NUMBER 013

### Renault 1.5 DCI / Accessory drive / Installation Info.

<b>GATES REFERENCE:</b>	<b>Accessory drive belt</b>	
MAKE:	RENAULT	
MODEL:	Clio II, Express, Kangoo, Rapid, Symbol	
MOTOR:	1.5 DCI	
MOTOR CODE:	K9K700, K9K702, K9K710

Fig. 1

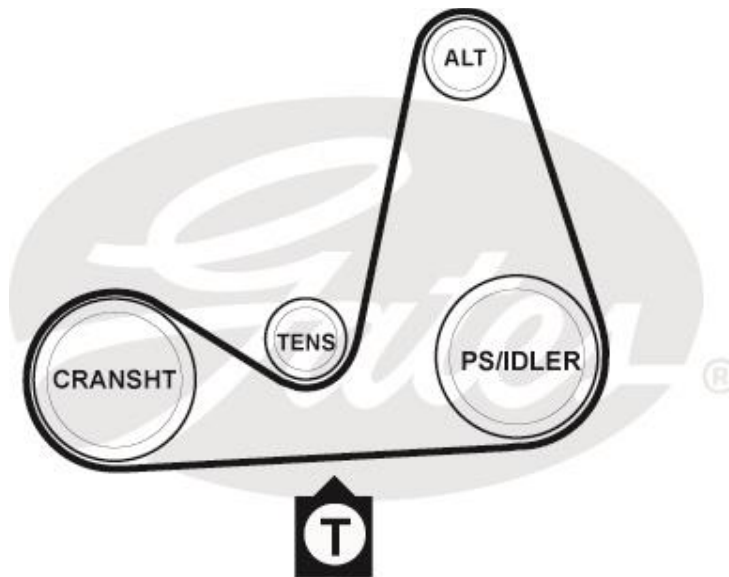
8. Tension the belt: the belt has to be tensioned (with tool Mot.1638, OE ref. 0000163800) to a higher tension than with the original drive set-up. Measure the tension in the bottom span, between the crankshaft and power steering pump (or idler for cars without power steering) (Fig.1).

9. When measuring the belt tension with the STT-1, key in “8”, “180” (virtual span of 180 mm). When measuring with the Krikitt<sup>®</sup>, tension has to be 70 Kg.
10. Now tighten both bolts (36 Nm).
11. Rotate the engine 2 revolutions clockwise.
12. Check the tension and adjust if needed.
13. Re-install all removed parts.
